DIXIE-NARCO, INC.
SERVICE BULLETIN #143

MODELS: DN174-6, DN204-6 and DN246-6 Adaptables (DOUBLE PORT MODELS ONLY)

SUBJECT: 10 oz. Can Shim - Accessory Kit (Reference B/M164,011,000.04).

FIGURE I

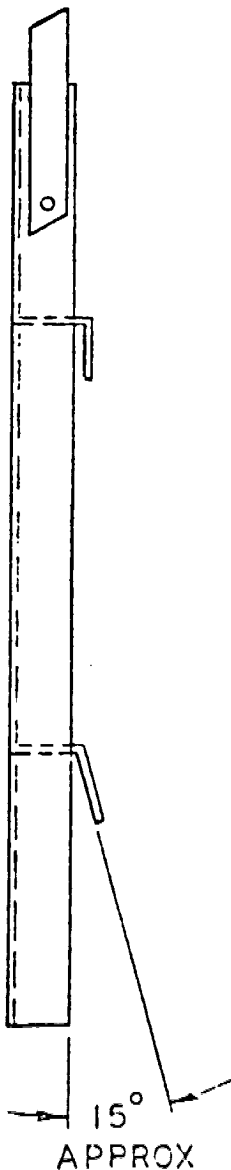
DO THIS: The lower tab on the can divider must be bent at approximately 15° as shown in Figure I, to allow for the additional metal thickness of the 10 oz. can shim.

The lower tab on the can divider after being bent, as above, shall be inserted through the rectangular hole in the shim, with the longer side of the shim forward, as installed in the vender, and the upper portion of the shim flat against the column wall.

FIGURE II
10 oz. Can Shim Installed
on Right Column

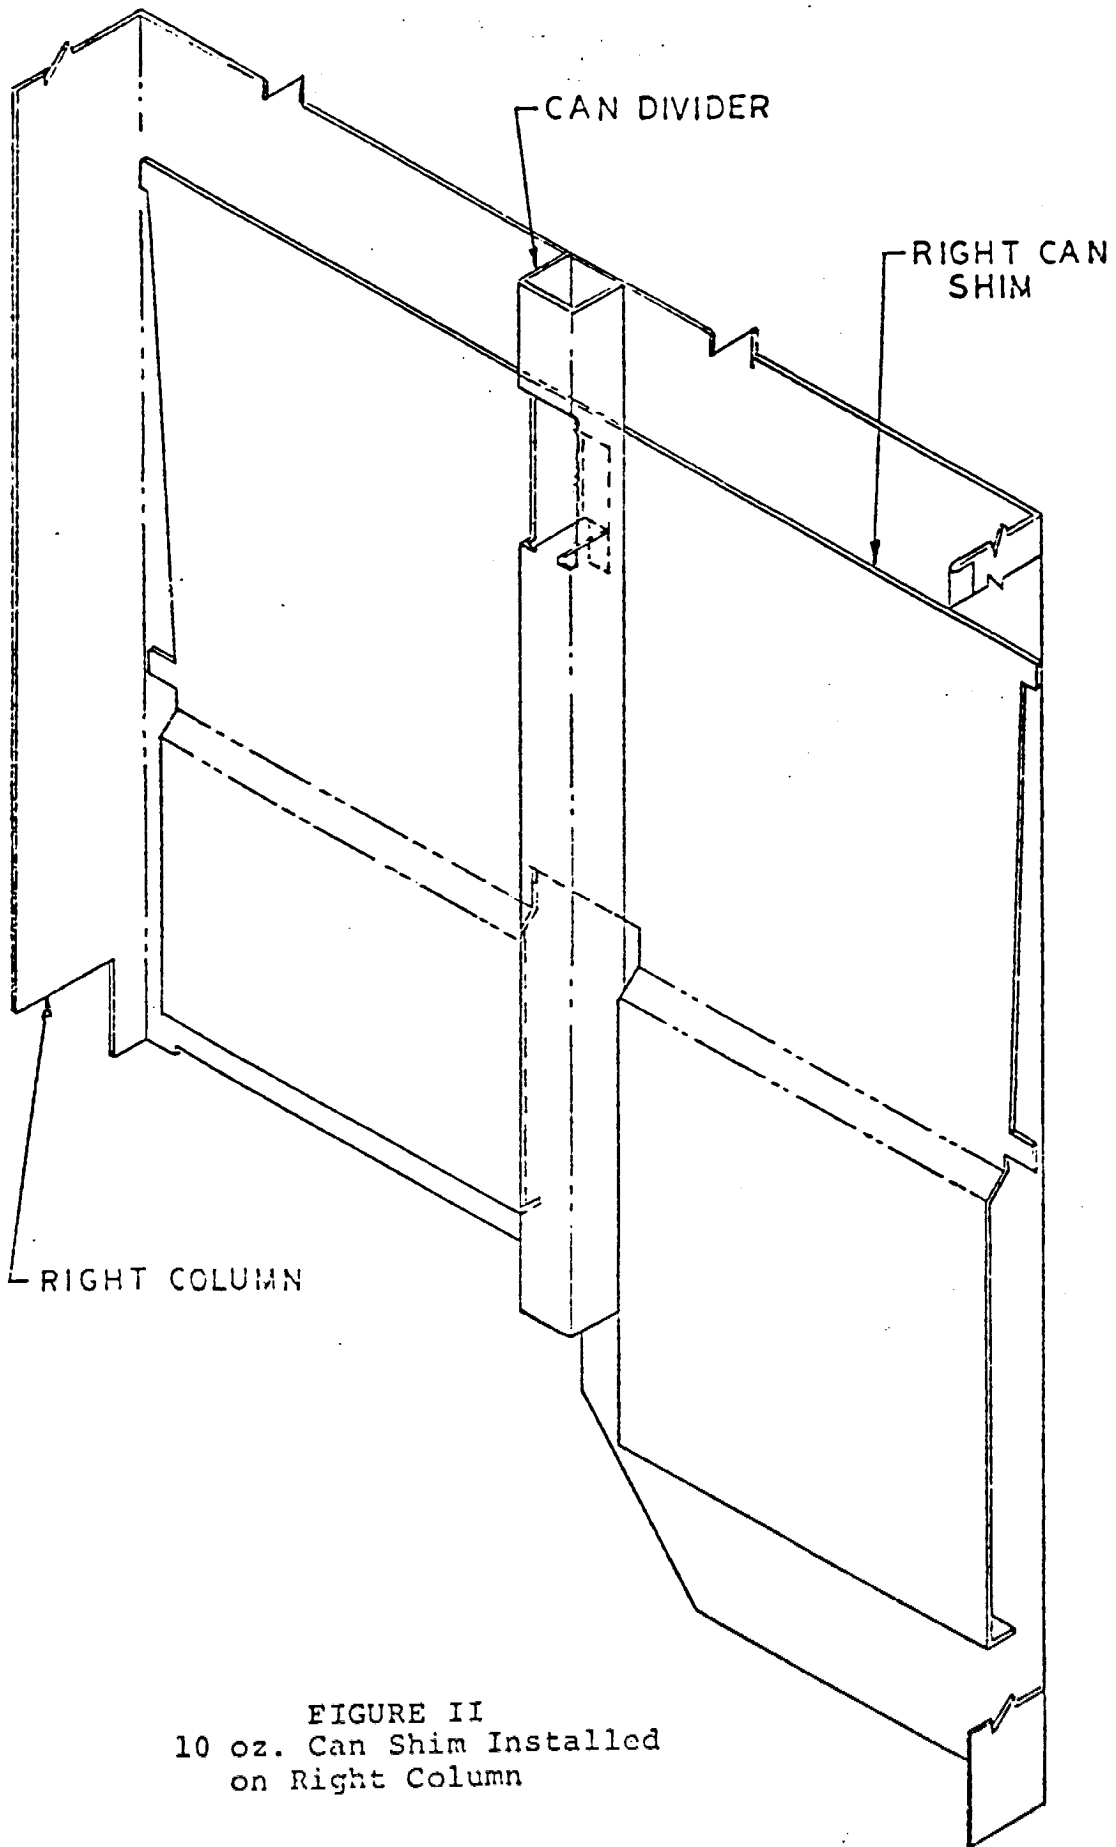
These two pieces, the can divider and the 10 oz. can shim are then installed in the vender in accordance with the instructions, Page 8, referred to above. See also Figure II, Page 2, of these instructions.
